PLANNING AND ENVIRONMENTAL PROTECTION COMMITTEE

TUESDAY 19 FEBRUARY 2019

SUPPLEMENTARY AGENDA

BRIEFING UPDATE

Document nos 1a (a)

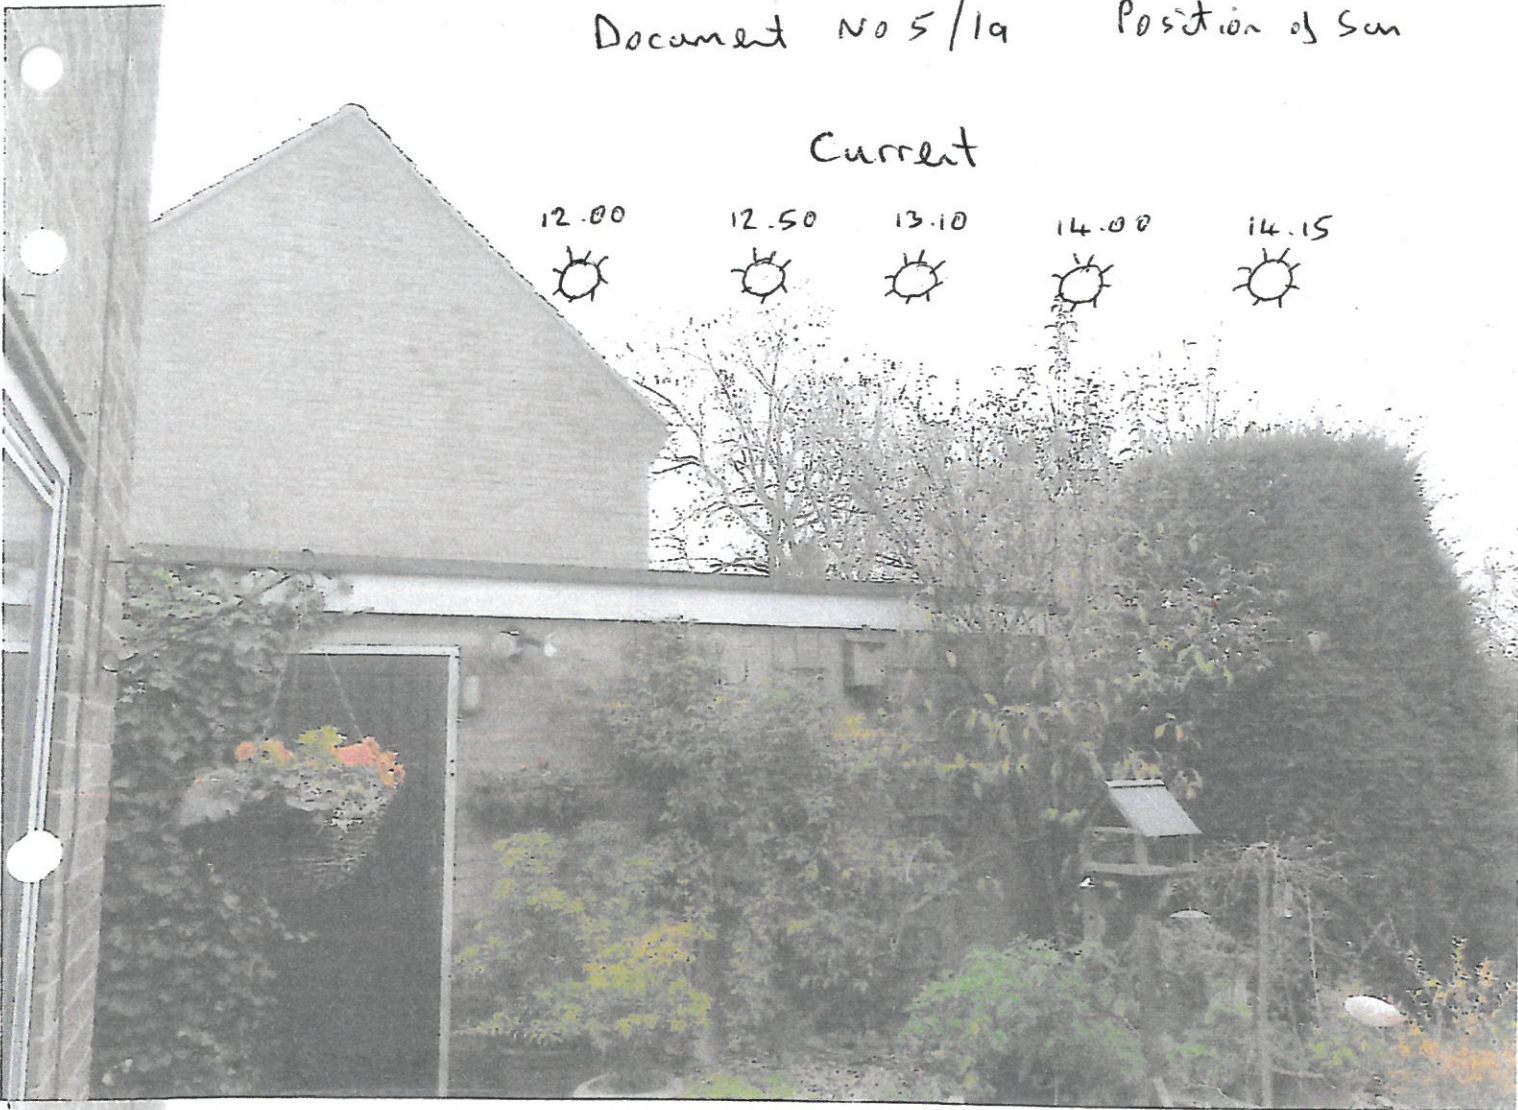
2. **Overbearing/loss of light:** Document titled Document no5/1A shows the overbearing nature of the extension and how it cuts out the direct sunlight to our dining/living room between 12 and 14.15 each day. This photograph and the position of the sun has been independently witnessed by 2 people (signed letters attached).
Document no 5/1b shows a table of the times of the sun disappearing behind the proposed extension.
Document No5/1c demonstrates the existing pattern of shading from no 3 and the shading that will result from the new extension.
Document no 5/1d shows the angle of the new extension roof and the angle of the sun between October and February to demonstrate the loss of sunlight during this period.

I can confirm that the photograph titled "Document No5/1a"

Is a true and accurate representation of the actual path of the sun as witnessed by me on 25th January 2019 and I can confirm that comparing this with the proposed extension plans for No 3 Maffit Road that the new extension would cut out the sun reaching the kitchen and lounge of No 5 Maffit Road between the hours of 12.00 and 14.00-14.15

- Several documents have been submitted by no.5 Maffit Road which show diagrams and figures of potential overshadowing. These are attached in full under Appendix A. The issues have been discussed in the report. Officers have no further comments to make.

DOCUMENT N05/1d

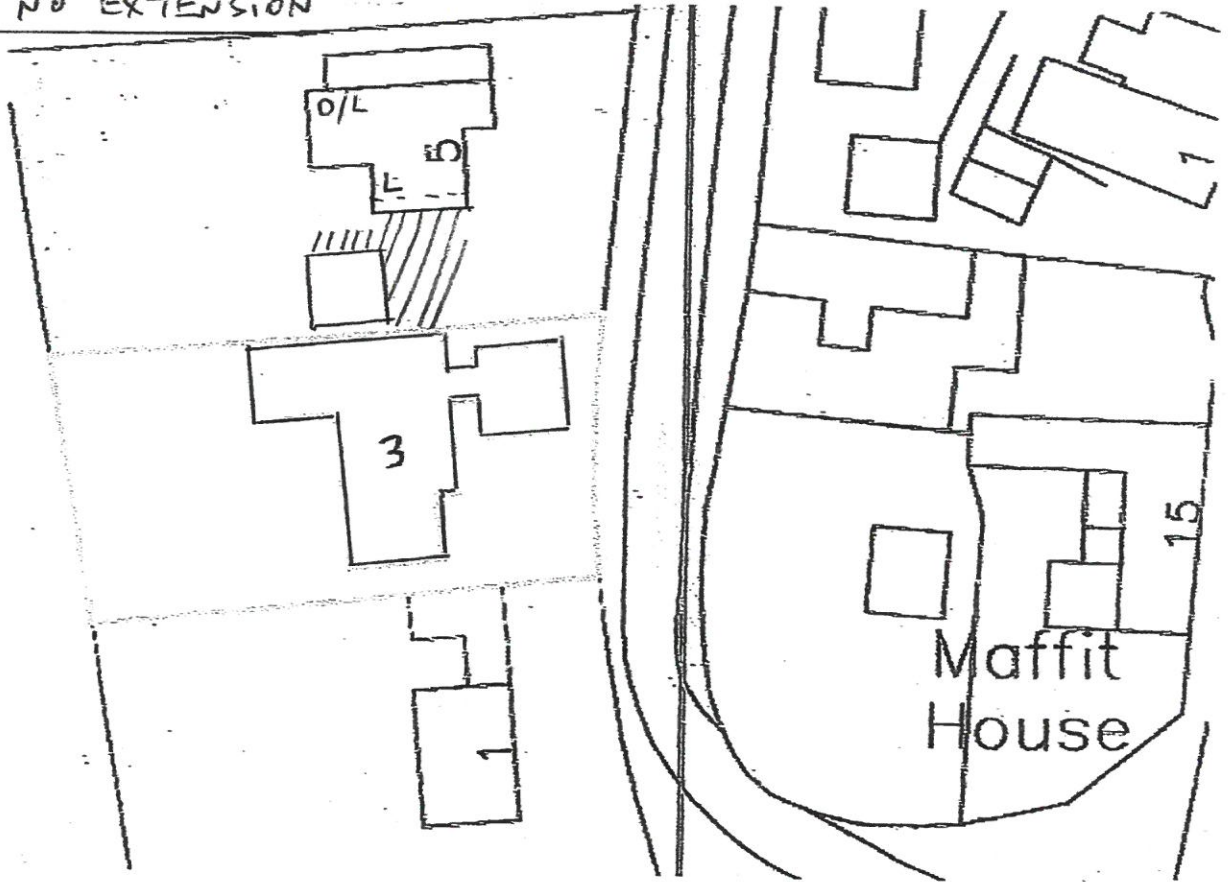
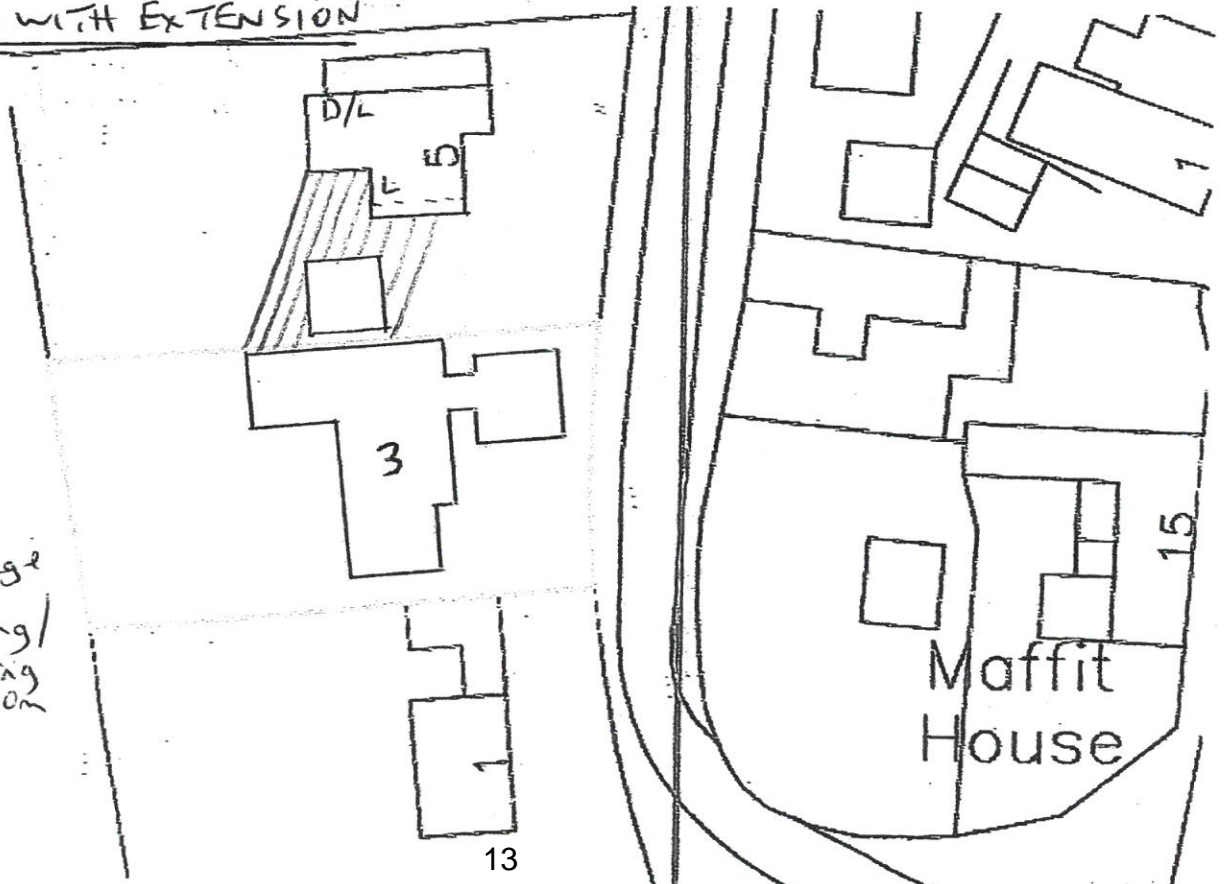
Overshadowing of No 3 on No 5 12.00 - 14.00

Overshadowing of No 3 on No 5 12.00 - 14.00

Therefore lounge and kitchen/dining/living room windows would be in the direct shade caused by the new extension from 24th October to 18th February each year (118 days) = 32% loss of mid-day sunlight over a year.

Maffit Road Plans of Properties

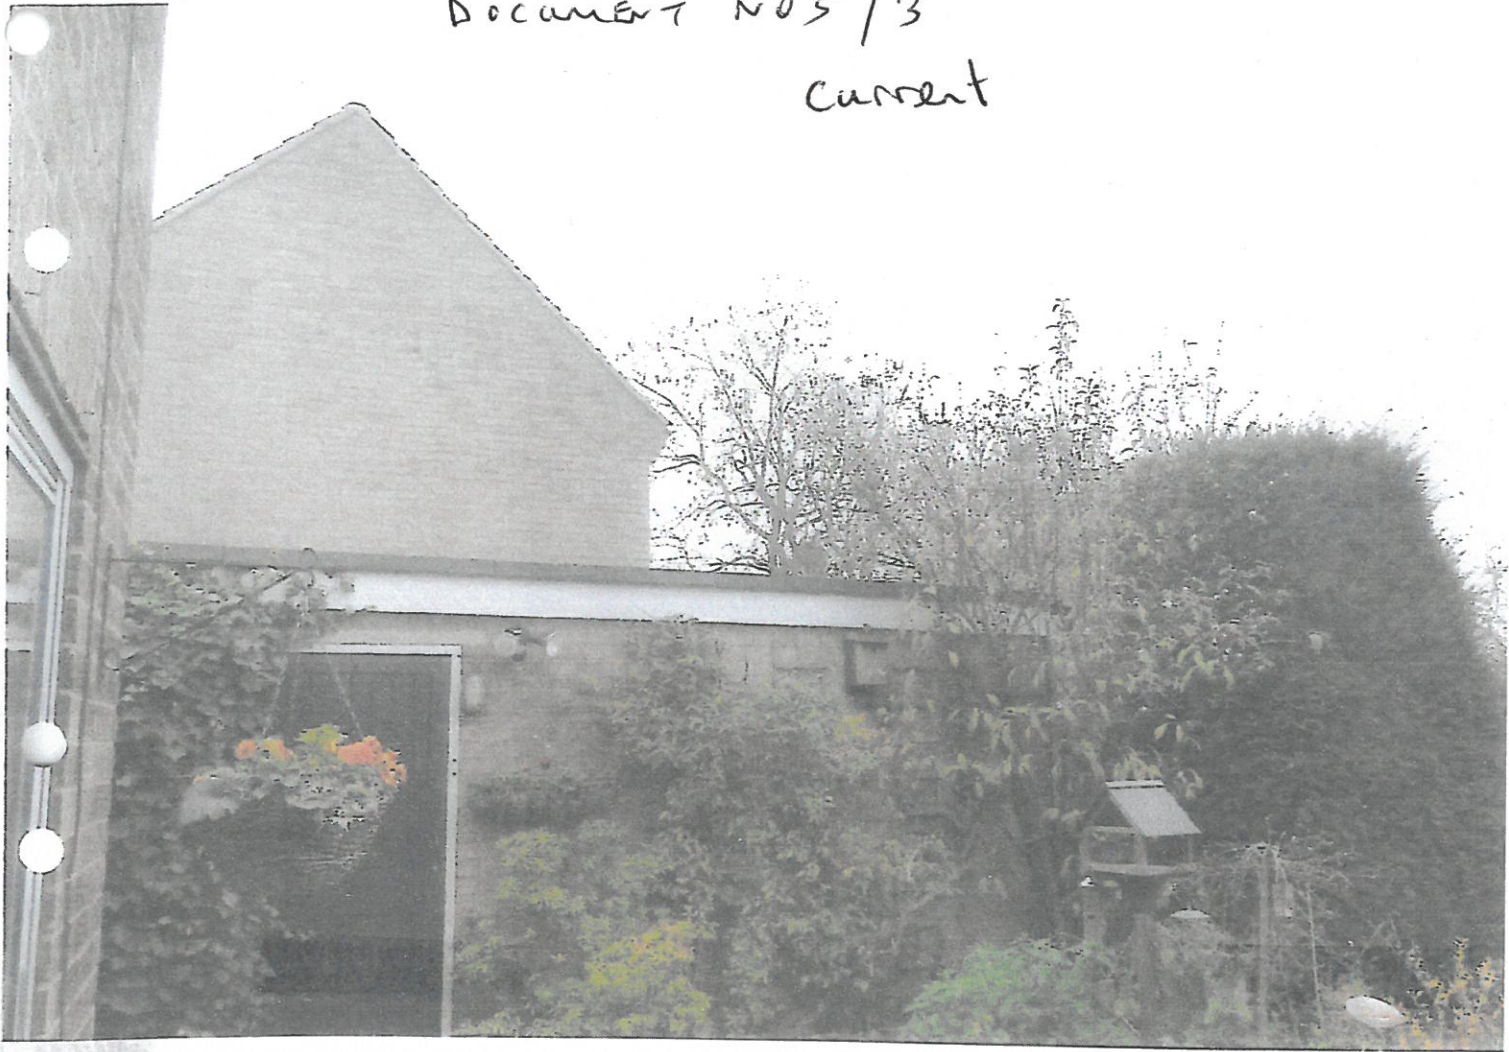
3. **Size/Scale of Property and no3:** The existing house at No3 is already one of the largest in Maffit road, occupying a greater % of its plot than most of the properties in Maffit Road and the greatest width of any house as a % of the width of the plot. The proposed extension will only serve to exacerbate the oversize of the property at no 3 compared to all of its neighbours and most others in Maffit Road.
Document no 5/2a demonstrates the % size of no 3 and the extent into the plot compared to the rest of the west side of Maffit Road,
Document no5/2b shows in plan form the % of plot occupied and the extent into the plot.
Document No5/3 shows the effect of a mono pitch roof in allowing direct sunlight to reach no5, Document no 5/3a shows the effect of a low pitch roof.
The proposed extension will be completely out of scale and not in sympathy with any neighbouring properties in Maffit road which is contrary to the policies of the Neighbourhood Plan.

Plot Sizes and Widths - West side of Maffit Road					
House No	Estimated % of Plot Occupied	Estimated % width of plot occupied	rear extension within 2m of neighbour's boundary	Estimated % Depth into plot from Maffit road	
1	7	42.8	N	41.6	
3	30	85.7	Y	69.2	
5	11	57.1	N	46.6	
7a	22.3	76.9	N	50	
7	11.8	75	Y	45	
9	5.5	50	N	23.8	
11	18	80	N	42.8	
15	13.2	50	N	33.3	
17	12	80	N	53.3	
19	12	80	N	53.3	
21	12	80	N	46.6	
23	11.3	57.1	N	54.5	
25	7.9	50	N	47.6	
27	9.8	57.1	N	33.3	
29	7.2	62.5	N	45.4	
Notes					
% plot calculations include 2 storey buildings not single storey side garages with flat roof					
% width calculations include 2 storey buildings not single storey side garages with flat roof					
Calculations made from block plans of Maffit Road taken from Peterborough City Council Planning Dept.

DOCUMENT nos / 3a

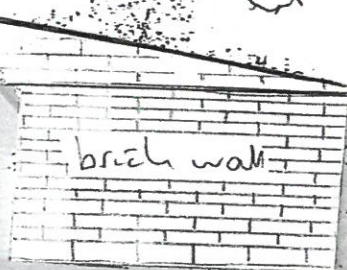
with 4m extra, + mono pitch roof

dramatically increased – and very different to the current situation.
“the pitched roof would face away from the neighbour, further reducing the impact”	P8 para 2		The pitched roof will face towards No5 and is approx 2.3m high by 5.7 m long adding significant visual impact and loss of light to No 5
“proposal would create one more bedroom”	P8 para 9		No 3 is currently a 4 bedroom house and will still have 4 bedrooms if these plans are built – with a reconfiguration of existing interior space to include a dressing room and a second en suite bathroom.
“The Tree Officer has not raised any objections”	P9 para 2		In fact the Tree Officers Report concludes “Tree information is required prior to the decision so that it is obvious what the impact to trees onsite and immediately offsite is” and “an understanding of the impact as stated above is required pre-determination”. So the Tree Officer states that further information regarding trees on and off site is required before any final decision regarding the trees can be made.
